VALUE ENGINEERING TRAINING STUDY REPORT

Buford Highway Sidewalks

Project No. HPP00-0013-01(062)

PI No. 731770

Results

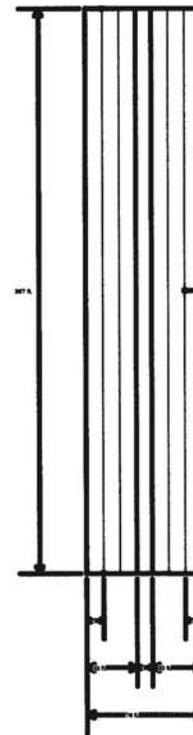
DEVELOPMENT AND RECOMMENDATION PHASE			
Project: SR 13/US 23 Buford Highway			
Idea No.: B-1	Sheet No.: of	CREATIVE IDEA: Staggered Lighting	
Comp By: Group 5 Date:10/8/2009 Checked By: Group 5 Date: 10/8/2009			
<p>Original Concept:</p> <p>Holophane 12 ft. MH Post Top-150 Watts Type II. Total number of lighting posts is 236.</p> <p>Proposed Change:</p> <p>Type IV, Long roadway lighting with spacing of 367 ft. for 2.2 miles. Will results in a reduction of 204 poles.</p> <p>Justification:</p> <p>Currently the plans call for Holophane Luminaries with 360 degrees of spread. We recommend changing the lights to Mongoose Holophane G400HP00HWCXXX Long, Type IV, Non Cutoff. This will allow the total number of poles to be reduced by 204 and will also channel the lighting towards the road. With the Holphane 12 ft MH Post Top-150 Watts 160 degrees of light is directed away from the road. Cost savings based on \$170.00 per year for one luminarie x 204 x 30 years.</p>

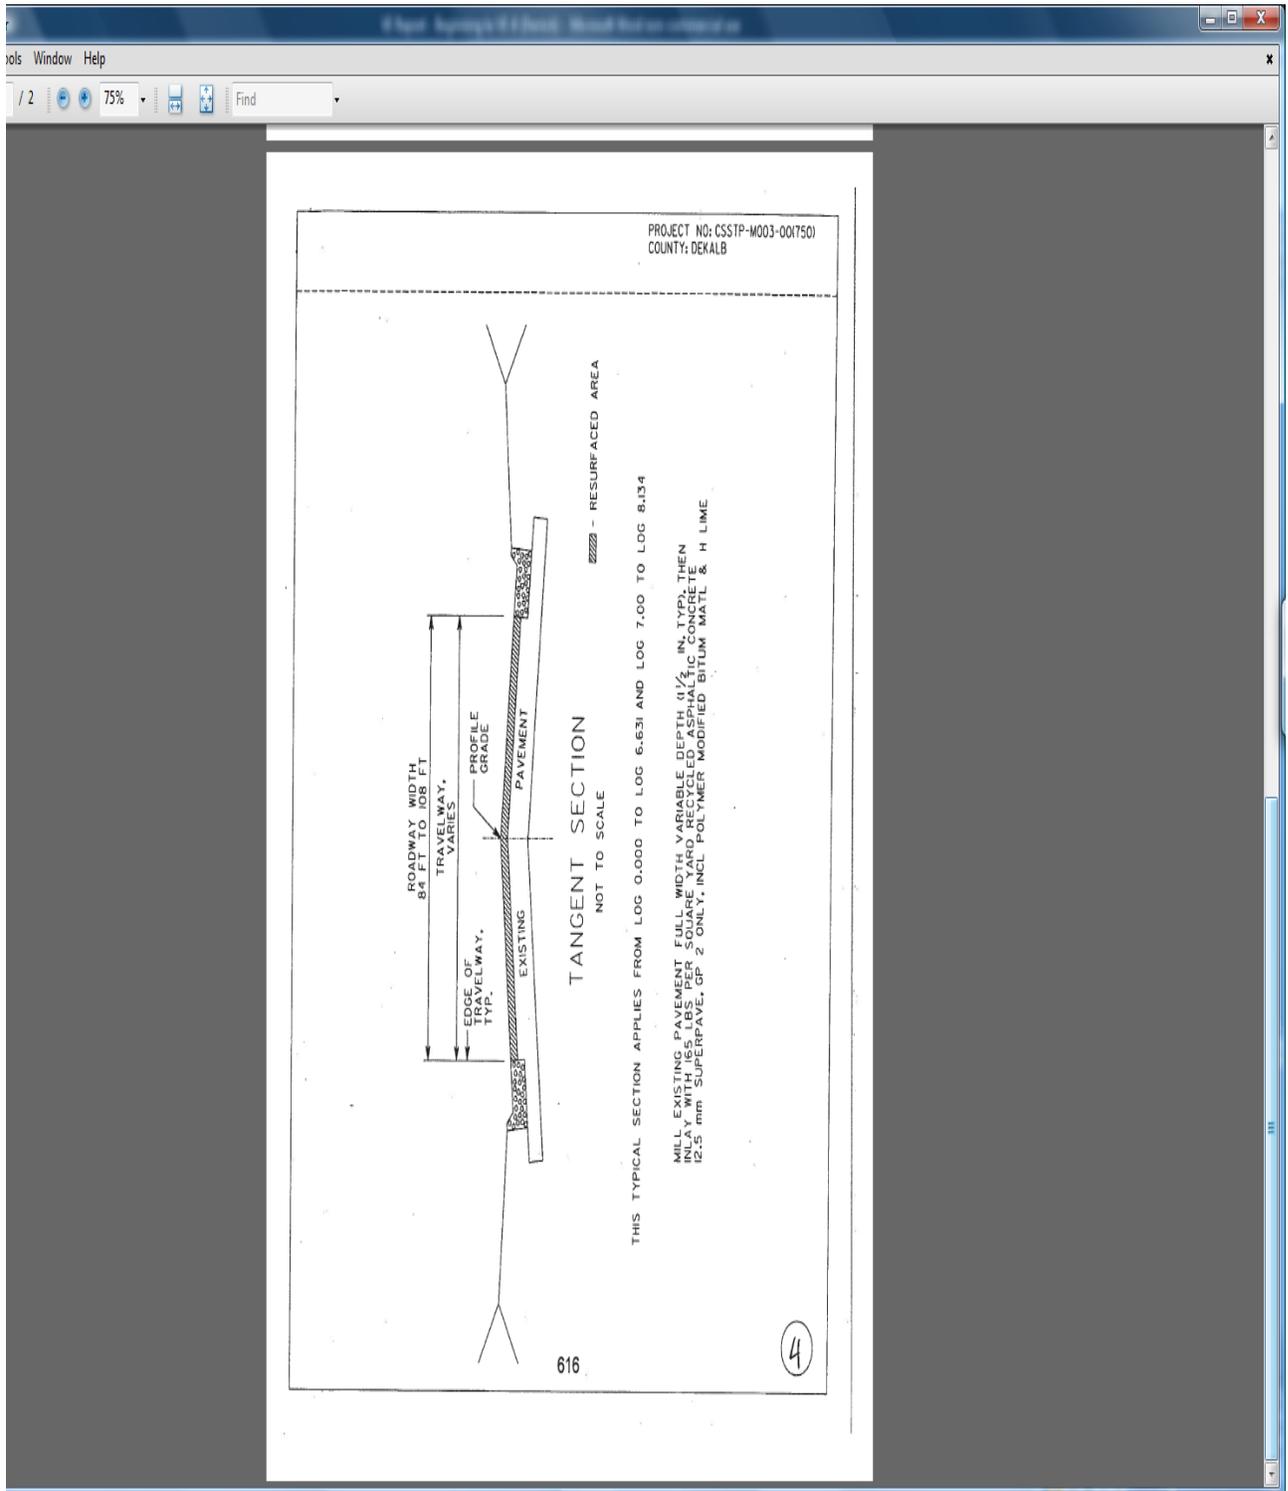
DEVELOPMENT AND RECOMMENDATION PHASE			
Project: SR 13/US 23 Buford Highway			
Idea No.: C-1	Sheet No.: of	CREATIVE IDEA: Milling & inlay outside lane and widening a portion of roadway (Hydroblasting necessary)	
Comp By: Group 5 Date:10/8/2009 Checked By: Group 5 Date: 10/8/2009			
Original Concept: This project proposes to Mill & Inlay 1 ½ " of the roadway section. The projects' primary purpose of this application is to "cleanly" remove striping, as to eliminate the presence of "ghost striping". The removed pavement would be replaced with 12.5 mm superpave recycled asphalt. The 12.5 mm asphalt will also be applied over the class B concrete in the proposed widened section.			
Proposed Change: It is recommended that only the outside lanes and the proposed widen section of the corridor be milled and overlaid. It is further recommended that these minor striping conflicts be corrected using hydro blasting.

Justification: This corridor was recently resurfaced under project PI M003750 which was completed in early 2008. Retaining this recently paved surface will cut overall project cost, while still providing the end user a smooth ride.			
LIFE CYCLE COST SUMMARY	INITIAL Project Cost	FUTURE Project Cost	TOTAL Present Worth Cost
INITIAL COST: Original	\$598,427.80		
Proposed	\$169,861.87		
Savings	\$428,563.73		
FUTURE COST: Savings		0	
TOTAL PRESENT WORTH SAVINGS			\$428,563.73
